Bayshore Bikeway/San Diego Coastal Trail
Final Mitigated Negative Declaration/Initial Study
(May, 2009)
Addenda and Second Addenda

**BAYSHORE BIKEWAY
PROJECT
(Segments 4,5,7, and 8A)**

**Final Mitigated Negative Declaration/
Initial Study**

May 2009

Typical Cross-sections - SDG&E Easement and SD&AE Railroad ROW

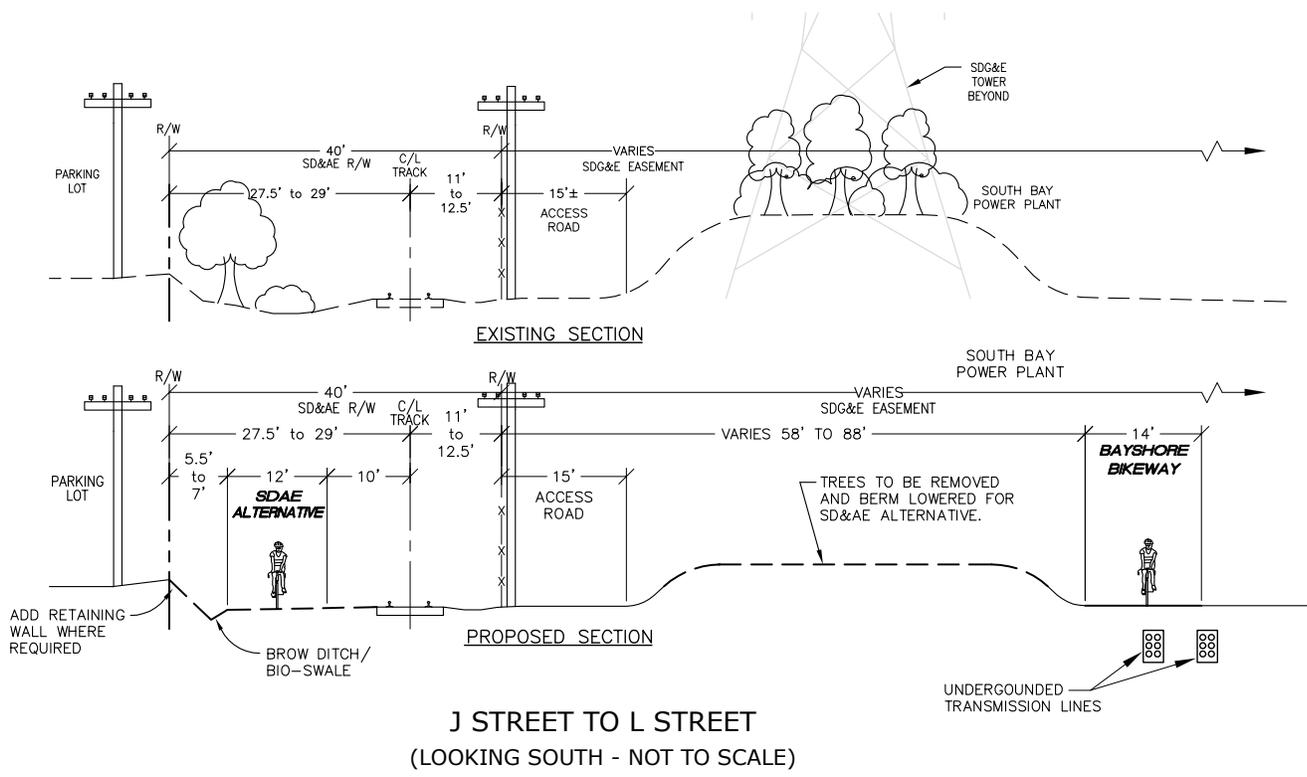
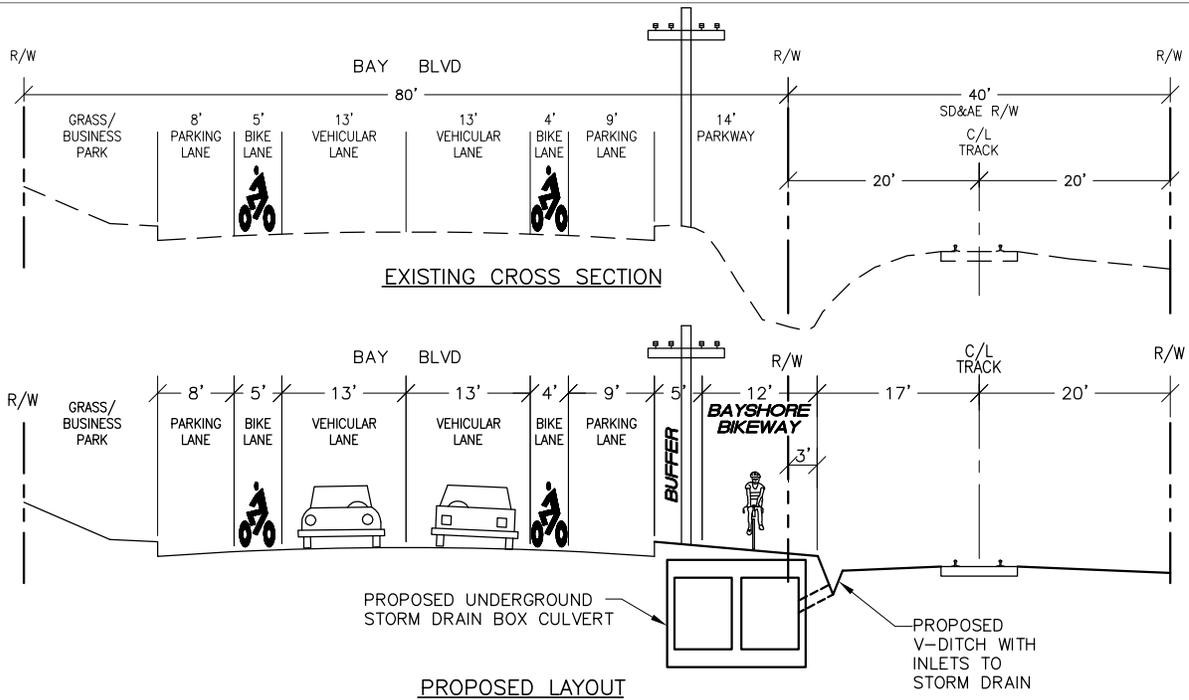
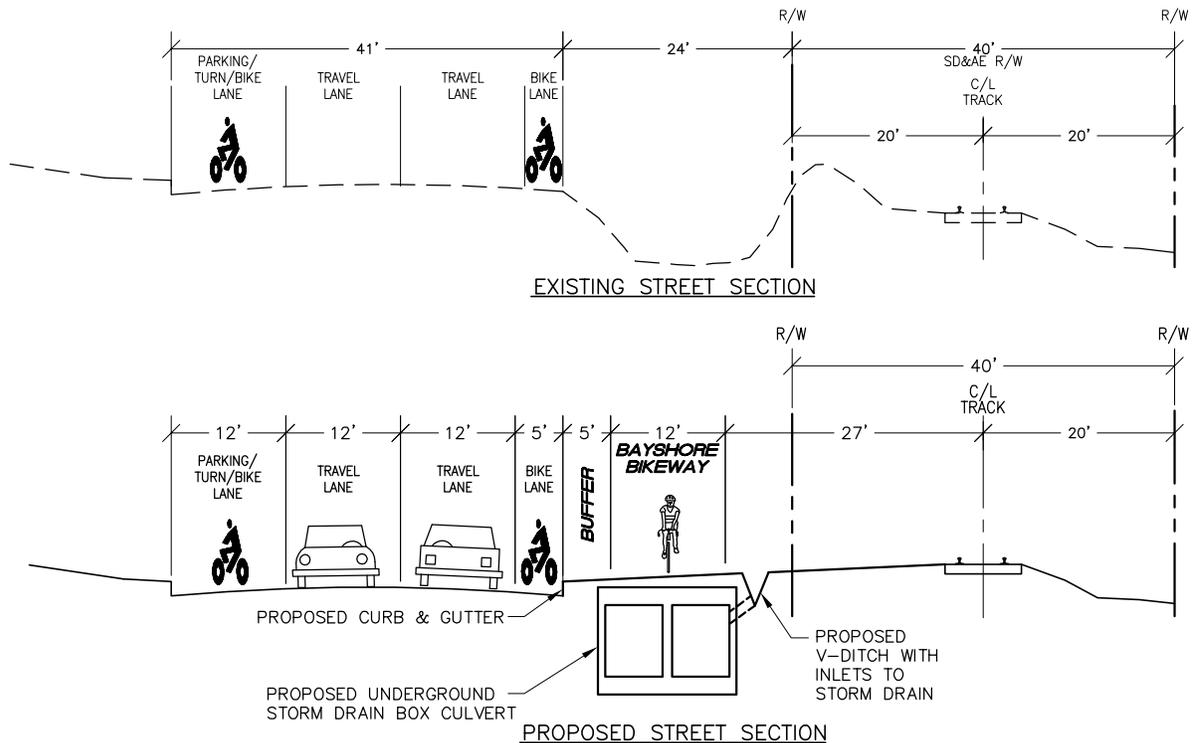
- H9 [• Segment 8A - Figures 10 and 15 illustrate the bike path between Stella Street north to the entrance of the bike path on the Power Plant Property. SDG&E has an overhead electric

- H2. The MND has been revised to identify that the project requires approval from SDG&E regarding use of the utility corridor for a portion of the bike path.
- H3. The MND has been revised to identify that the project may be required to complete a Section 851 filing with the California Public Utilities Commission.
- H4. Refer to response H1 above.
- H5. Refer to response H1 above.
- H6. Refer to response H4 above.
- H7. Refer to response H1 above.
- H8. Comment noted. Refer to response H1 above.
- H9. Refer to response H1 above.
